## TKLN/134 . Response to HKPF comments

## TKLN/134 . Response to TD comments

## Swept Path Plan

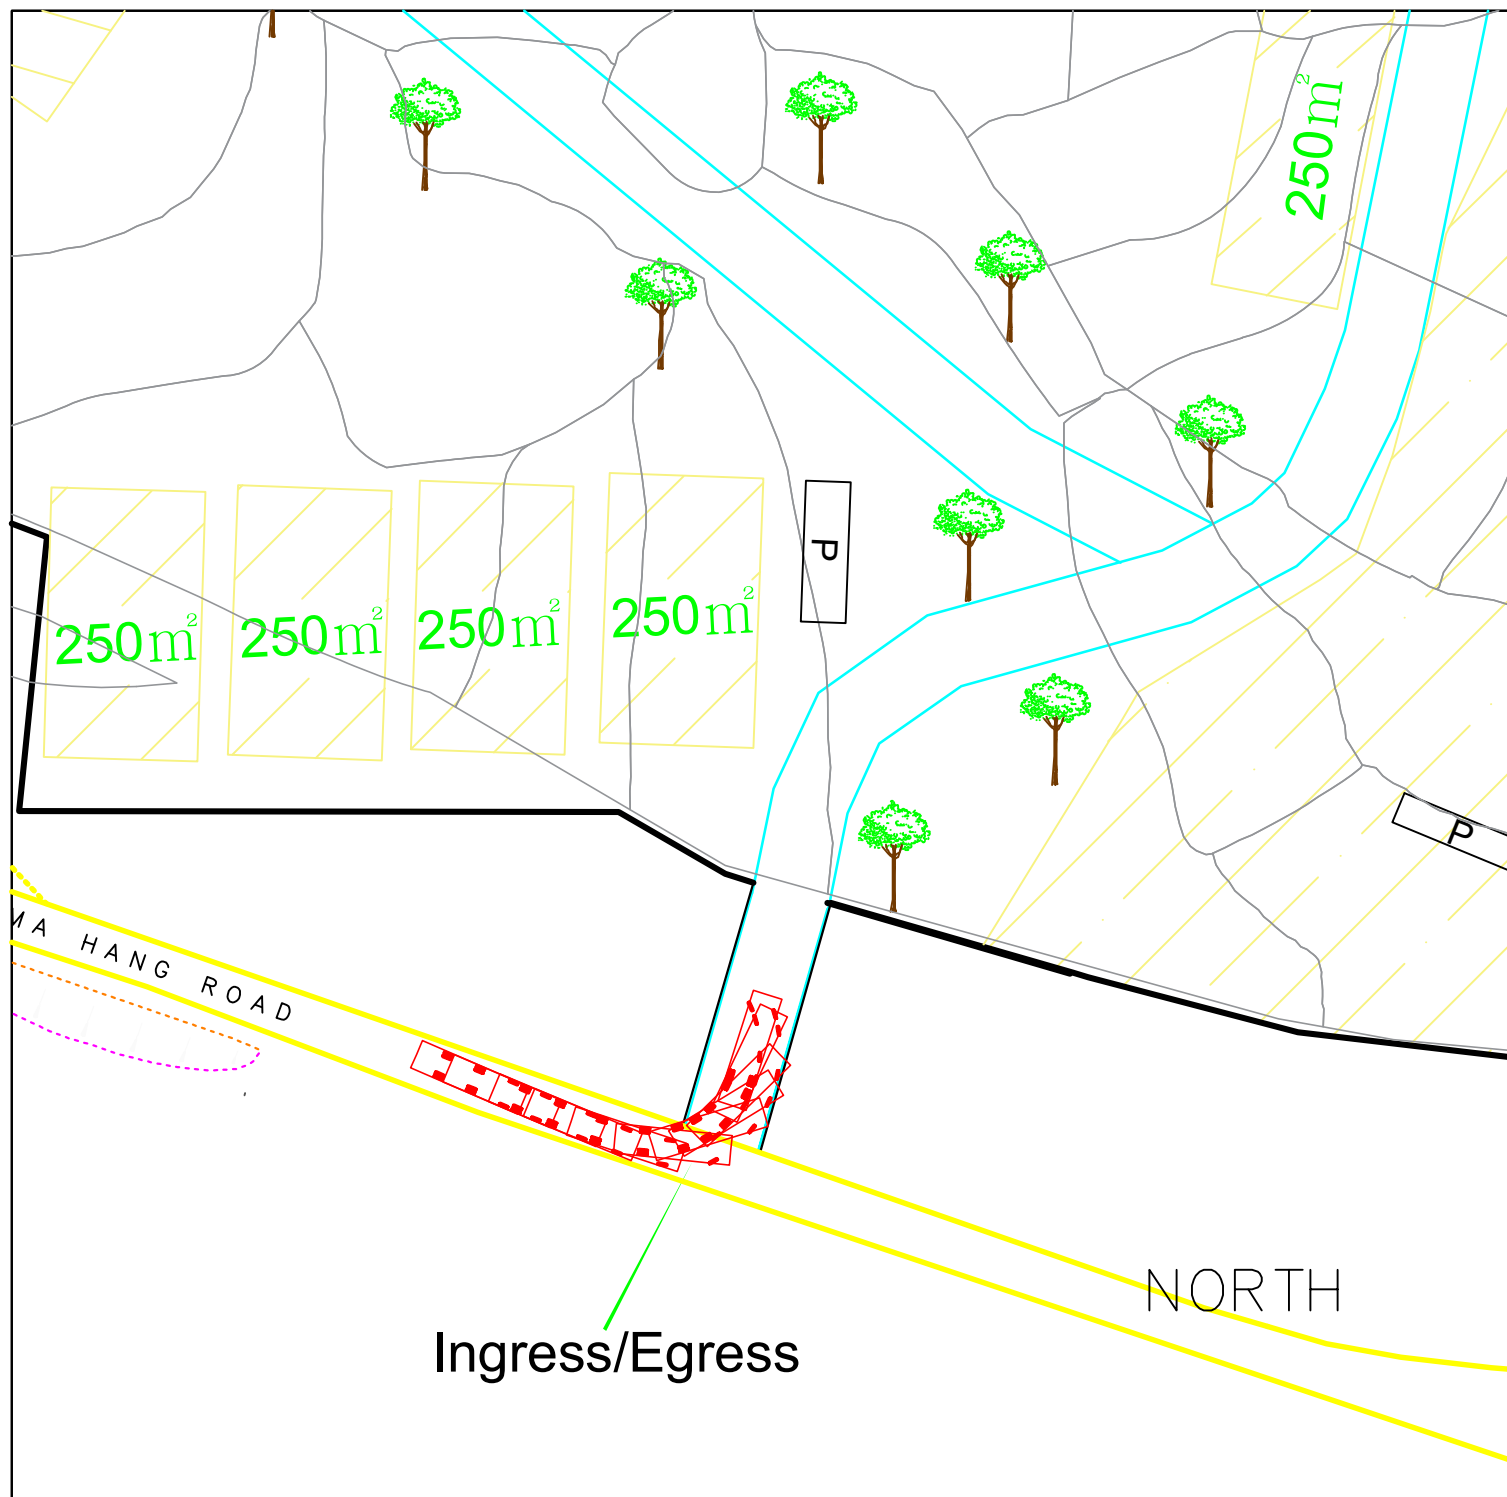
| in Annex 14, the swept path beyond Lin Ma Hang Road and the ingress/Egress point. The applicant shall revise it |

| Noted. Please refer to revised Annex 14                                                                         |

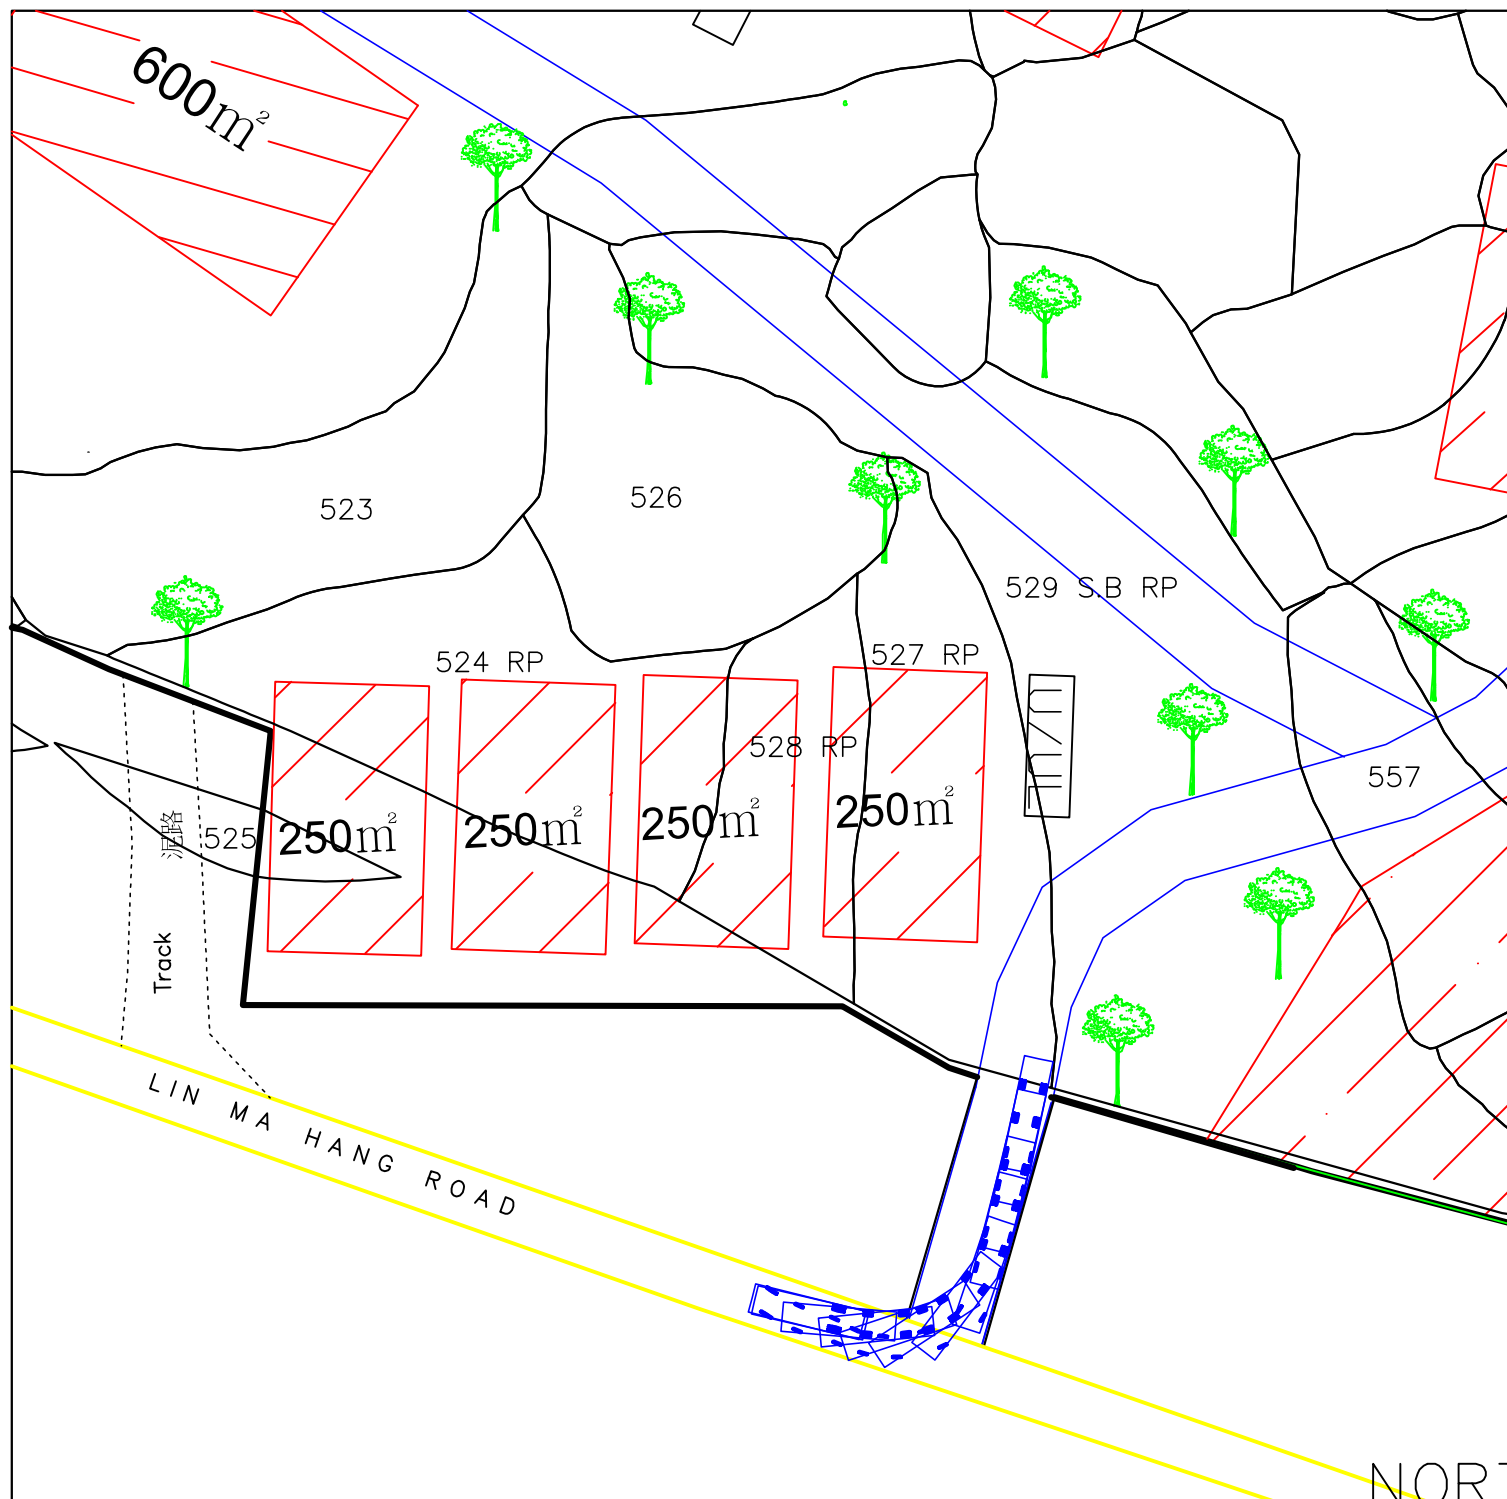
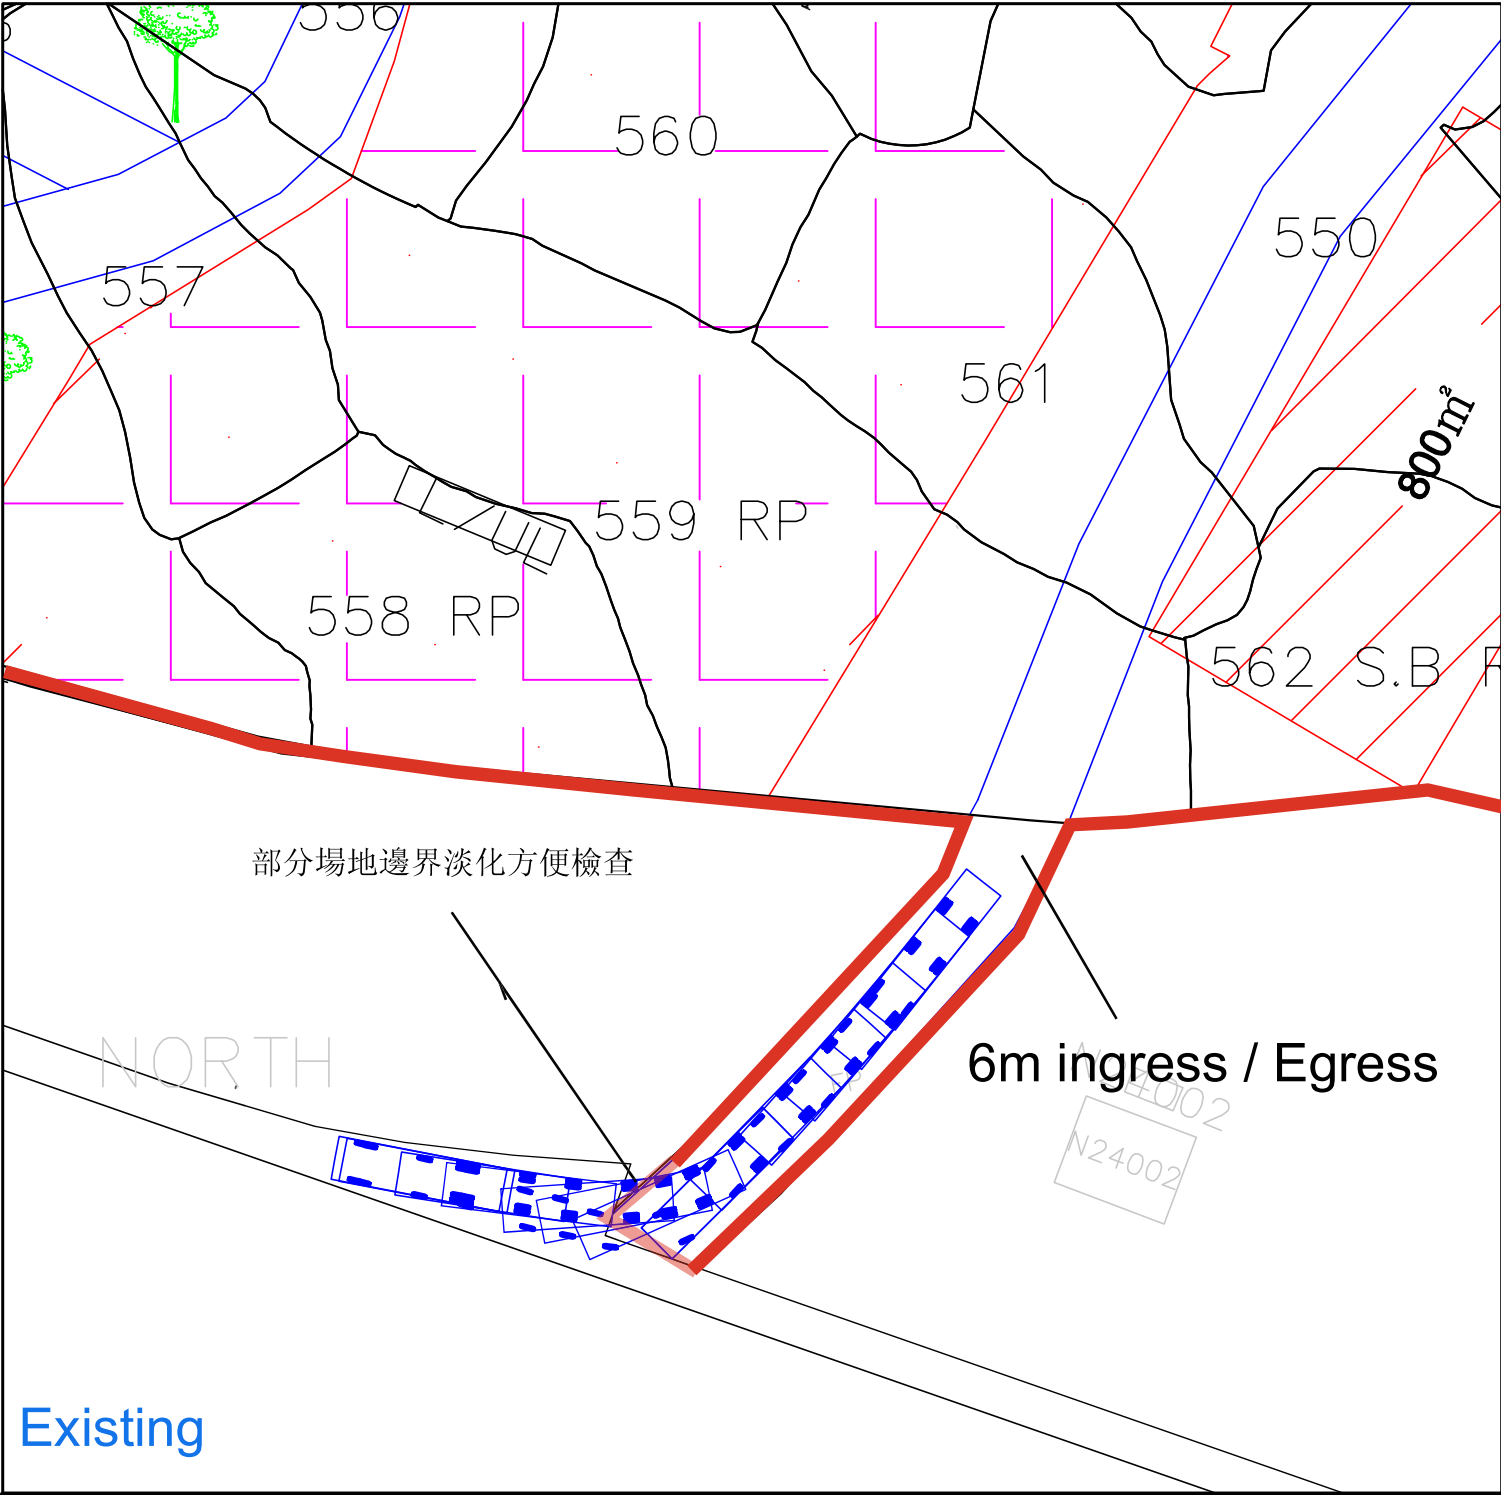
the applicant should demonstrate the satisfactory maneuvering of the goods vehicles when exiting the subject site via the three ingress/egress points;

The related swept path plans are provided.
